MOSS PARK DAYCARE

SUMMARY

<p>Owner/Applicant John JeBailey JeBailey Realty., LLC</p> <p>Project Planner Colandra Jones</p>	<p>Property Location: The subject property is generally located north of Savannah Park Drive, east of Narcoossee Road and west of Moss Rose Way (±1.44 acres, District 1).</p> <p>Applicant's Request: Specific Parcel Master Plan (SPMP) approval for a 16,208 square foot childcare facility with approximately 40 parking spaces.</p> <p>Staff's Recommendation: Approval of the request, subject to the conditions in this report.</p>	
<p>Updated: July 1, 2014</p>

DEVELOPMENT PLAN

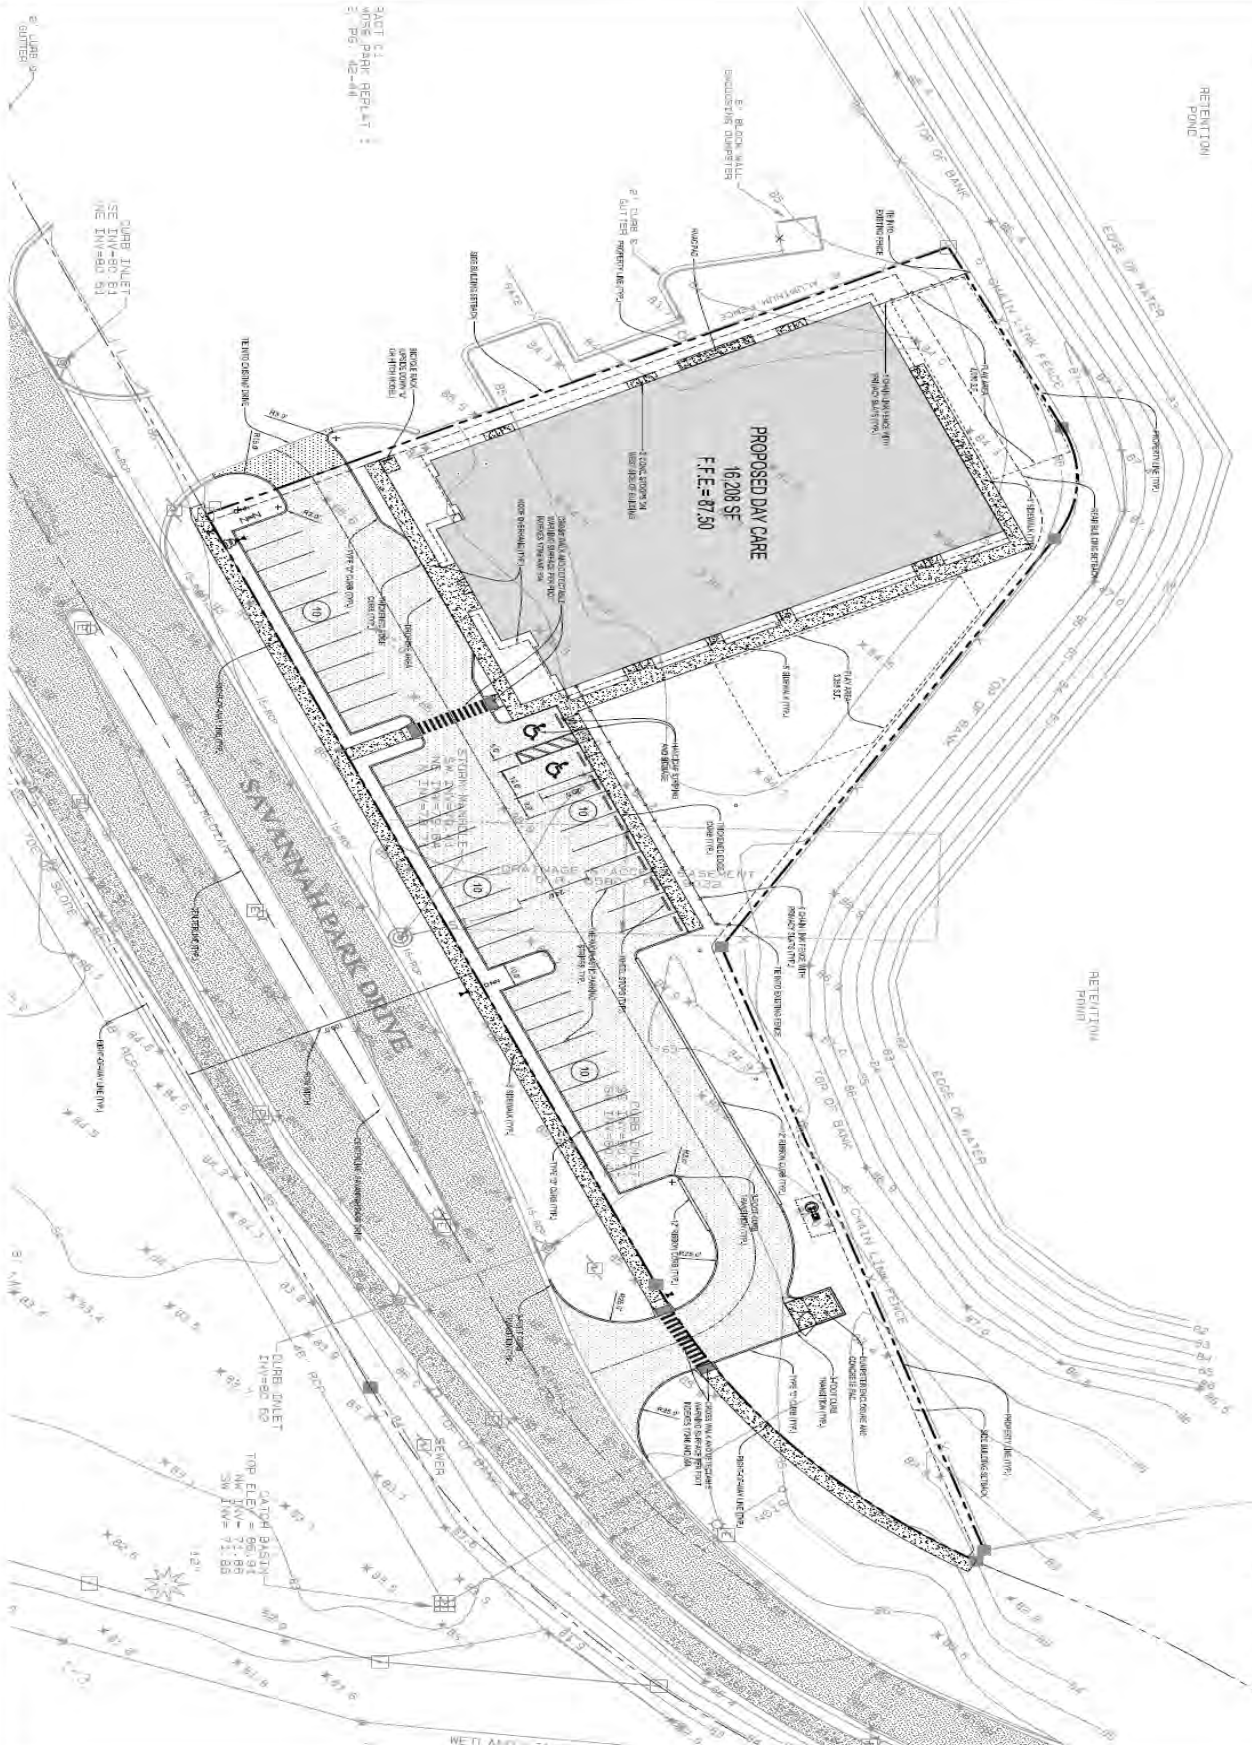
The SPMP proposes a screened dumpster enclosure on the east side of the property. The dumpster shall comply with Transportation Condition #14 on page 12 of this report.

The dumpster and lift station shall be screened. The dumpster shall be re-oriented in order for the open to not face the right-of-way.

- *Uniformity of light is crucial to avoid 'dark' spots, especially in the parking lot. In reviewing the plans, we see there are no lights planned for the west side of the building and lighting along the property border between the day care and retention pond is almost nonexistent. We strongly encourage the developer to consider reviewing these areas.*

- *Consider including gates in the fence from both play areas that are equipped with access control devices.*
- *Consider adding bollards along the south side of the building (main entryway) and between the parking area and play area east of the building.* Bollards provide visual access to property, increase a sense of ownership and territoriality for occupants, and control access to buildings and grounds by potential offenders and unauthorized vehicles.

LANDSCAPE PLAN

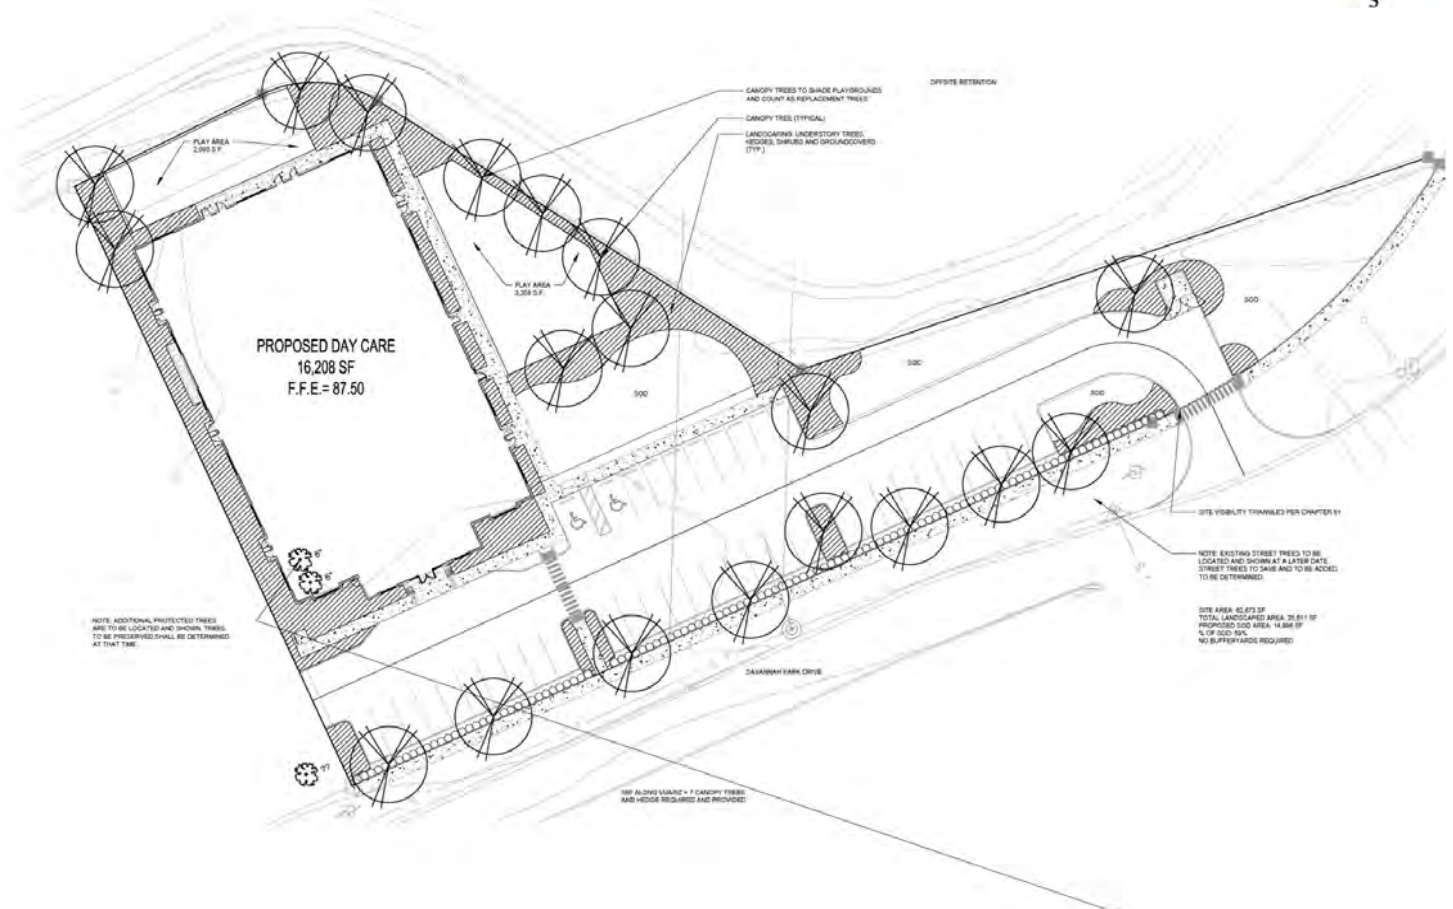
The applicant submitted a landscape plan with the application which can be found on page 7 of this report. It is noted that the landscape plan will be developed in accordance with Chapter 61 Part 3B of the LDC as it deals with Landscaping for Parking Lots.

- Tree branches should be kept trimmed to a minimum of 6 feet from the ground.
 - Branches should be kept away from roof. *We encourage the developer to review the tree placement on the north-west and northeast corners of the building as well as by the dumpster and consider other placement options.*

- Trees should not prevent building occupants from viewing entrances or sidewalks.
 - Tree canopies should not conflict with lighting. *We encourage the developer to review the tree placement in relation to parking lot lighting and consider other placement options.*
